UNITED STATES PATENT AND TRADEMARK OFFICE

APPLICATION NO.	FILING DATE	FIRST NAMED INVENTOR	ATTORNEY DOCKET NO.	CONFIRMATION NO.
09/982,584	10/17/2001	Jorn von Seggern	400004=2012	7560

Office Action Summary

DETAILED ACTION

Part of Fig. 4 of Greenwell '887

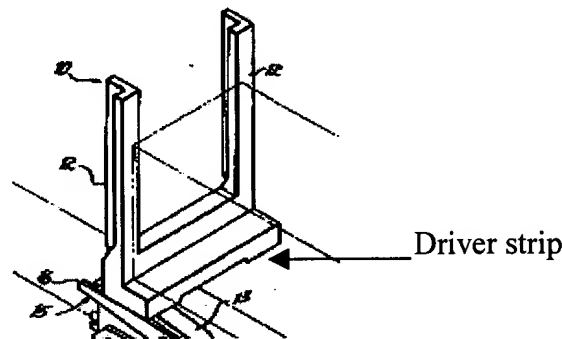
2. Claims 17-24 are rejected under 35 U.S.C. 102(b) as being anticipated by Greenwell et al. (USP 5,337,887).

Greenwell discloses all of the claim limitations in a similar conveyor apparatus for transporting objects shown in fig. 4, the apparatus comprising a plurality of continuously circulating guided conveyor lines (20, 20a) with drivers (10,11) arranged at intervals from each other wherein the conveyor line is constructed of continuously circulating individual chains (20) each of which has respective drivers (10, 11) arranged at intervals from each other, the intervals

between the drivers of different individual chains may be adjusted (C4/L20-26) simultaneously. Greenwell further discloses that the drivers (10, 11) are held on each conveyor line (20, 20a) so that they can be adjusted in the direction of transport (C4/L23-26) and that the drivers (10, 11) connected to each conveyor line (20, 20a) are located at fixed intervals from each other (C4/L41-63).

Greenwell additionally discloses that each driver has driver strips (fig. 4) that extend across all of the conveyor lines transversely to the direction of transport.
